NON-CONCURRENCE PROCESS COVER PAGE

NCP TRACKING NUMBER
NCP-2014-004

TITLE OF SUBJECT DOCUMENT
Incorporation by Reference Institute of Electrical and Electronics Engineers Standards, 603-2009

TITLE OF NON-CONCURRENCE DOCUMENT:
Position Paper on Staff Update to 10 CFR 50.55a(h) Rule Affecting I&C Systems

Figure 1:
Overview of International Standards as They Apply to I&C Related Nuclear Safety Systems

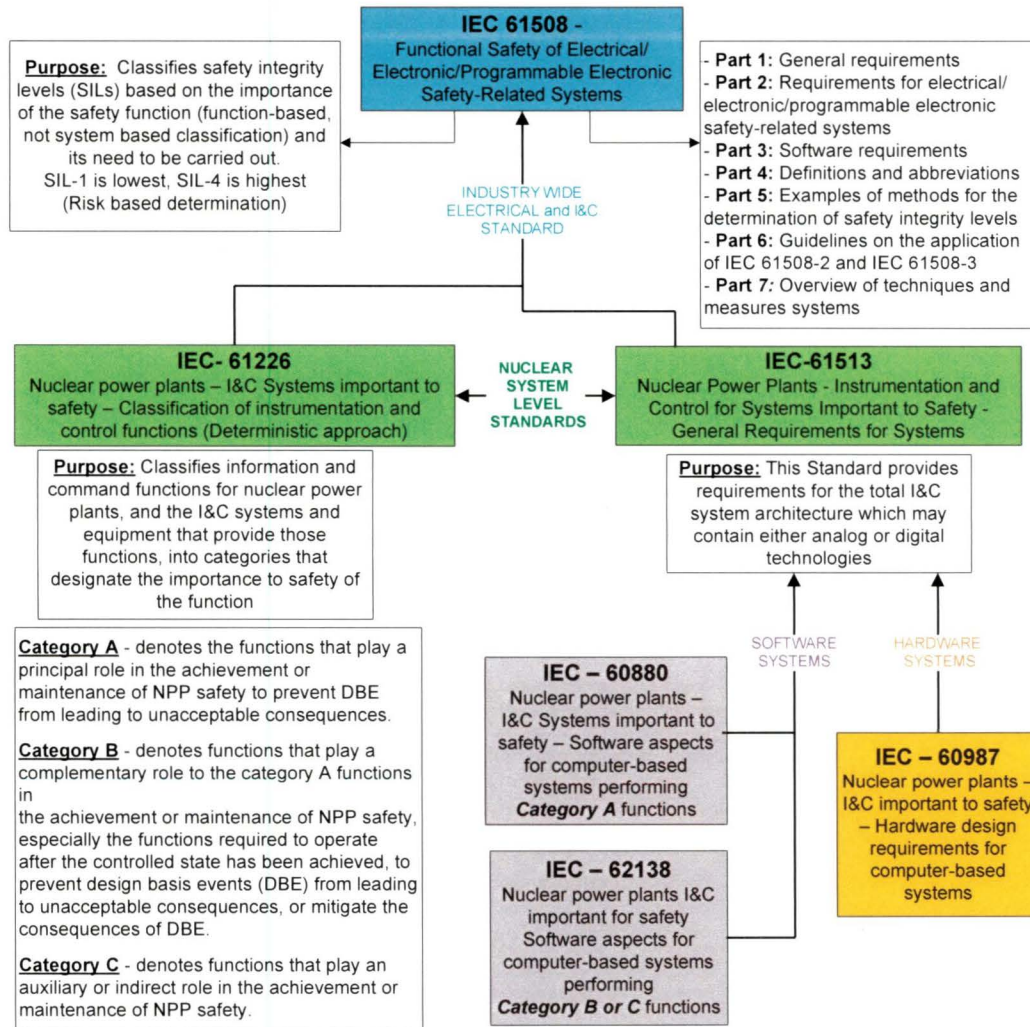
As displayed in Figure 1, the IEC Standards structure supports requirements for all I&C safety systems, such as those described in IEC 61508, and then provides design-specific requirements for digitally-based I&C safety systems within nuclear power plants, similar to those defined in IEC 61226 and IEC 61513.

The comparison would hold for the proposed two-tier regulatory structure that would apply to safety related I&C systems utilized in American nuclear power plants. These regulations would reference certain IEEE Standards for all I&C safety systems, such as those described in IEEE Std. 603-1991, and then create regulations that provide design-

specific requirements for digitally-based safety systems or other 'application-specific' characteristics within I&C safety systems. For example, one could apply a portion of those characteristics defined in IEEE Std. 7-4.3.2, which could be used as a starting point when developing regulations for digitally-based I&C systems.

Figure 2: Proposed Regulatory Framework for Protection and Safety I&C Systems

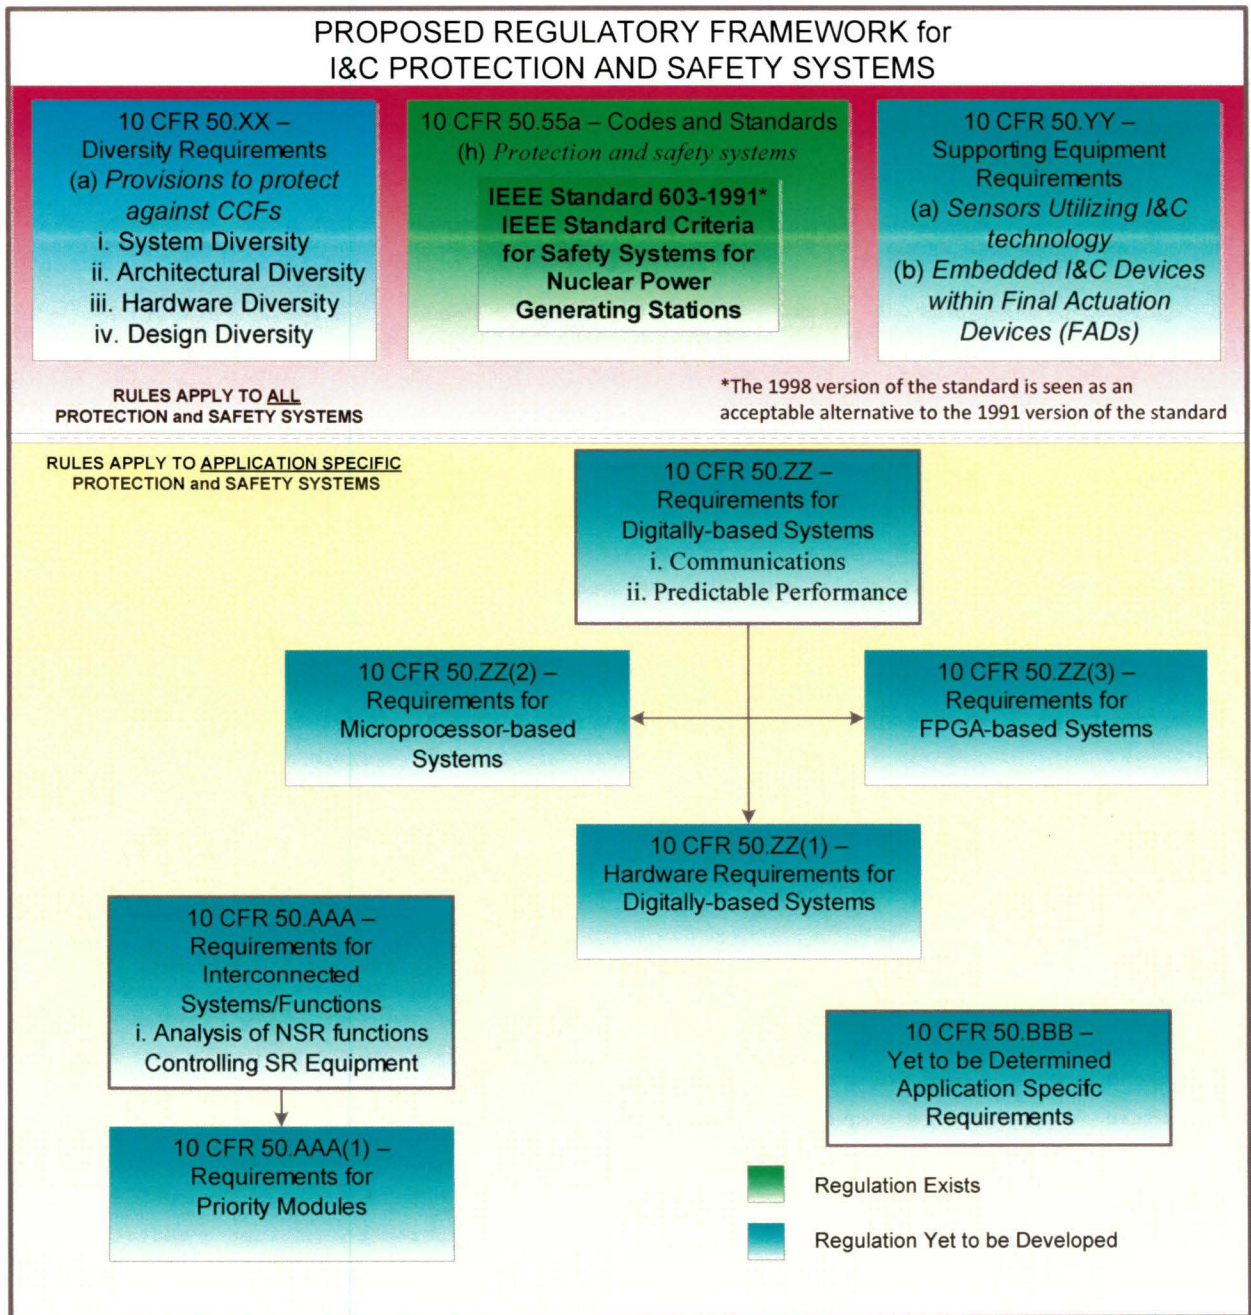
Utilizing this strategy provides a benefit since it would be possible to leave the 1991 version as the endorsed standard that applies to all I&C safety systems for nuclear power generating stations, while also allowing new language to be incorporated into another, more focused rule (or rules) that describes necessary design characteristics or attributes that pertain to 'application specific' applications for new or modified I&C systems. An example of this two-tiered approach to I&C protection and safety systems appears in Figure 2 (next page).

2. Implement the strategy using a two-tiered regulatory model – The non-concurrence recommends a two-tiered regulatory structure for I&C regulations and guidance. The recommendation would require a fundamental change in the I&C regulatory framework and requires additional consideration before proceeding. The staff determined that such a recommendation can be considered as part of the overall strategy described earlier above.
